PLANT NAME: OCONEE UNITS 1-3
jcm

Consists of Proposed revision to BAW
10094 transmitted by B&W Ltr. dated Jan. 24,
1977 to Mr. S. A. Varga, superseded the earlier
revision....

Reference: Oconee Nuclear Station
Docket Nos. 50-269, -270, -287

My letter of January 13, 1977 provided a proposed revision to the Babcock and Wilcox Company; THETA computer code as described in Topical Report BAW 10094, which was submitted by B&W letter dated December 20, 1976 to Mr. S. A. Varga. The attached proposed revision to BAW 10094 was transmitted by B&W letter dated January 24, 1977 to Mr. S. A. Varga and supersedes the earlier revision. LOCA calculations performed for the Oconee class reactors at the two and six foot elevations indicate that the Oconee Nuclear Station Technical Specifications remain valid to assure that the requirements of Appendix K to 10CFR50.46 are met.

FIGURE 1 HEAT TRANSFER MODES

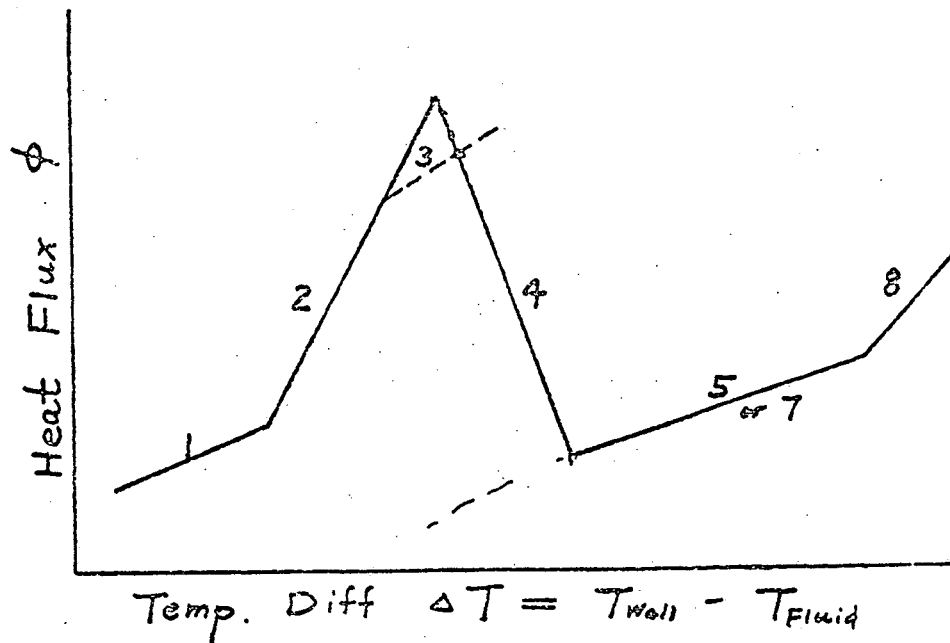
"If departure from nucleate boiling (DNB) has been calculated to have occurred for a particular axial node, both transition flow boiling and nucleate boiling will be calculated; the lower heat flux is used." Examination of the THETA6F switching logic showed that the comparison of transition boiling heat flux to nucleate boiling heat flux was not made. Rather, referring to Figure 1, a trial value of the heat flux was calculated for a particular axial node according to the fluid void fraction.

for: $0 \leq \alpha \leq .80$	nucleate boiling (mode 2)
$.80 < \alpha < .90$	interpolation between nucleate boiling (mode 2) and forced convection vaporization (mode 3)
$.90 \leq \alpha < 1.0$	forced convection vaporization

If the trial heat flux was less than CHF, the trial value was taken as the local heat flux. If the trial value exceeded CHF, transition boiling (mode 4) heat flux was used. To correct this, the post-CHF switching logic was modified so that, subsequent to CHF at a particular axial node, regression on the transition boiling curve is restricted to heat fluxes (1) less than CHF for local fluid void fractions less than 80 percent, (2) less than the heat flux calculated by interpolation between nucleate boiling (mode 2) and forced convection vaporization (mode 3) for local void fractions between 80 percent

and 90 percent, or (3) less than the heat flux calculated by forced convection vaporization (mode 3) for local void fractions greater than 90 percent. That is, transition boiling heat fluxes are restricted to values less than those calculated using pre-CHF correlations appropriate to local fluid conditions.

In the event that the local transition boiling (mode 4) heat flux is calculated to exceed the heat flux calculated using pre-CHF correlations according to local fluid conditions, the local heat flux is determined by switching to film boiling (modes 5 and 7). Thus, with this modification, the return to nucleate boiling is replaced by a temporary switch to film boiling.
